RECOMMENDATION  
ADMINISTRATIVE DESIGN REVIEW

SDCI # 3025269  
5637 University Way NE  
Seattle, WA 98105

Applicant:  
Cone Architecture, LLC  
2226 3rd Avenue  
Seattle, WA 98121  
Contact: Tim Carter

**DESIGN STANDARD**  
SMC 23.47A.008.B.3  
Street-Level Development Standards

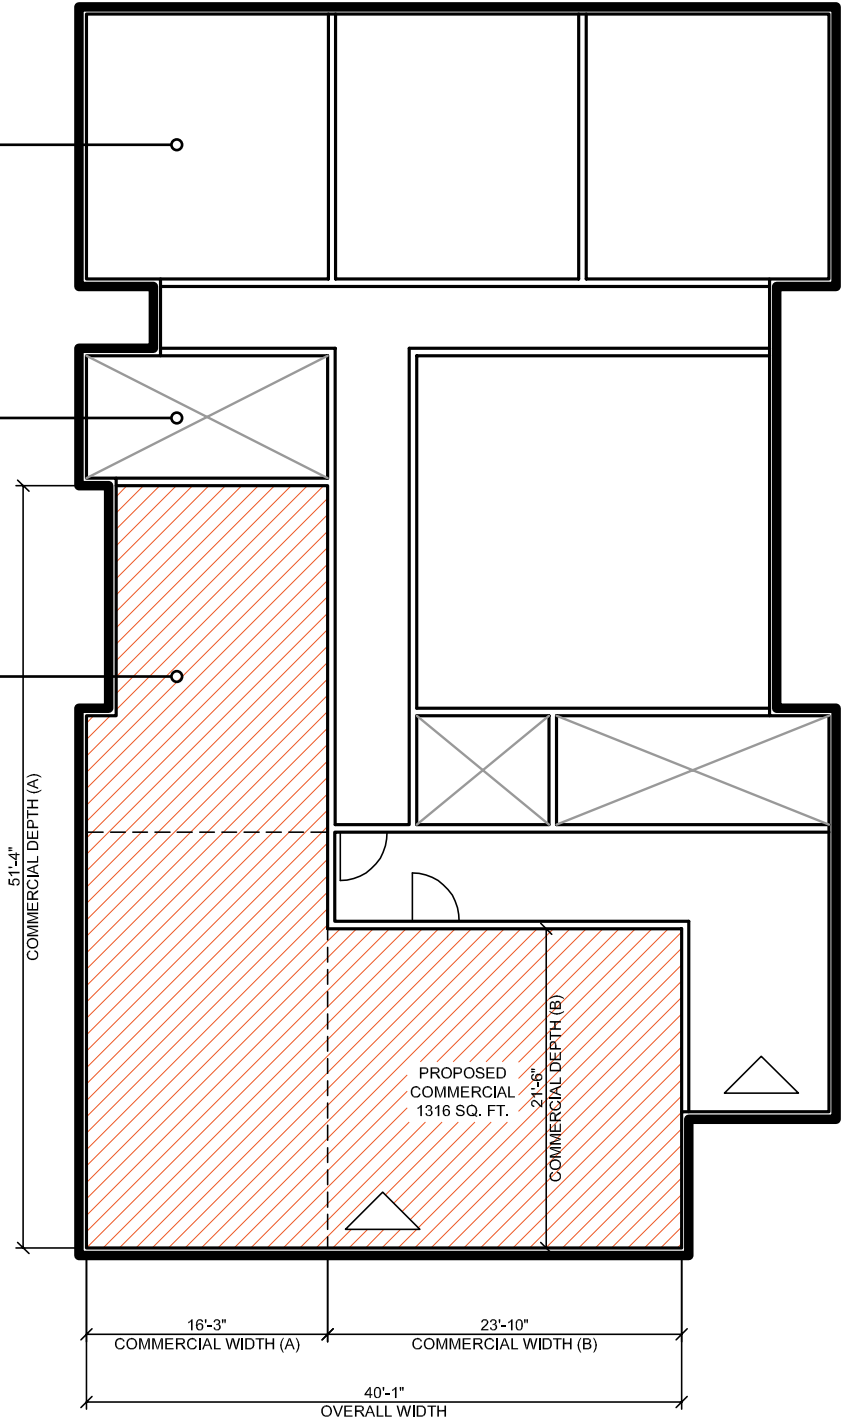
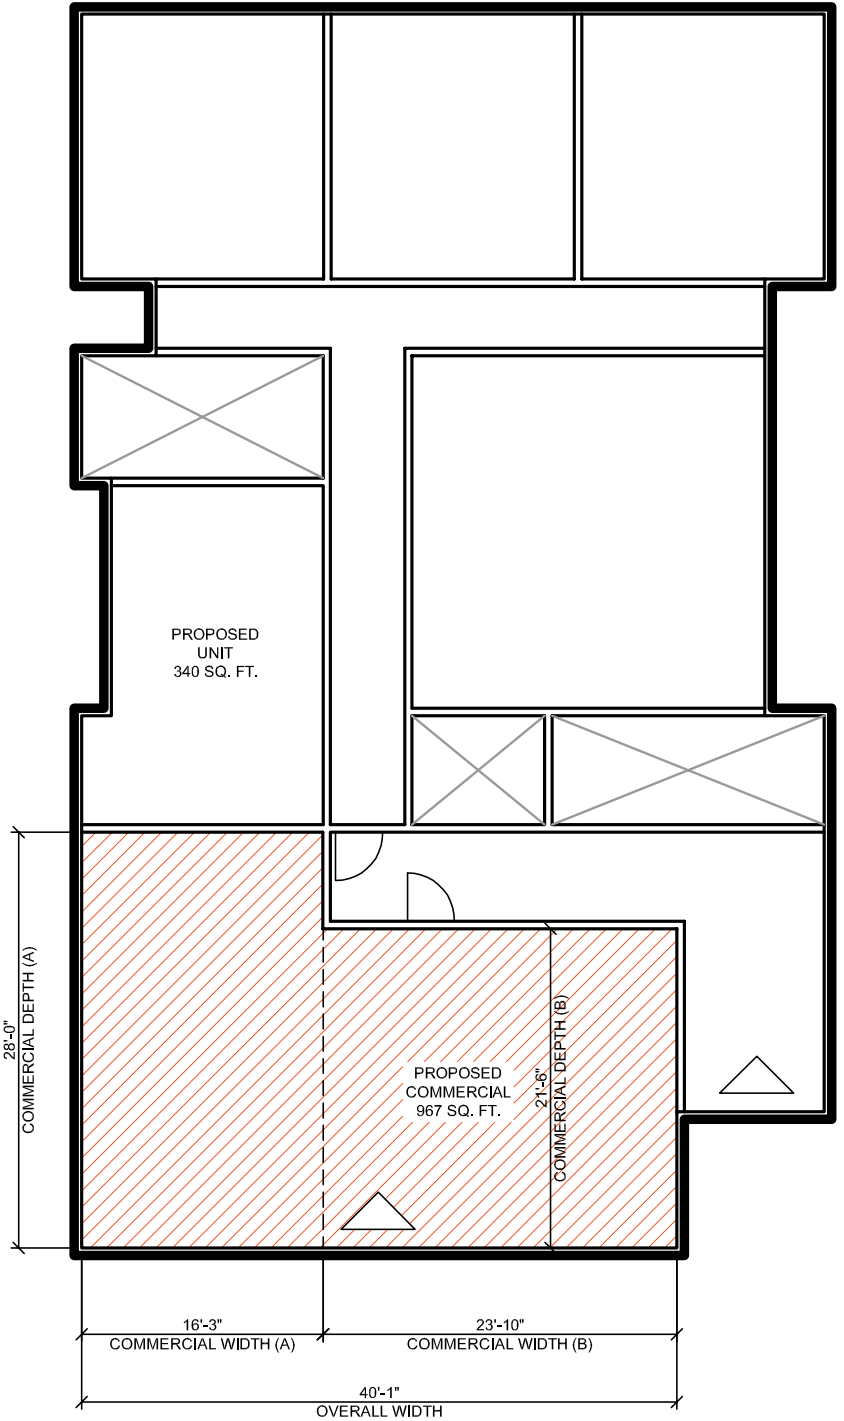
**DEPARTURE REQUEST**  
To allow the commercial depth to decrease from the required 30'-0" to 24'-2".

**RATIONALE FOR DEPARTURE:**  
This current commercial footprint is pinned in to its location due to egress separations and constraints put upon the project by adhering to the 15'-0" rear setback from the single-family zoning across the alley (to which the project now conforms per the early design guidance.) Therefore, the only way to create a conforming commercial space is to remove a unit and extend the commercial into the unit. This creates a low-quality space that has little connection to the street front. In addition, the overall width exceeds the required depth. The proposed departure takes the required depth and puts it directly adjacent to the sidewalk to promote additional street-level interaction and improve the commercial light quality.
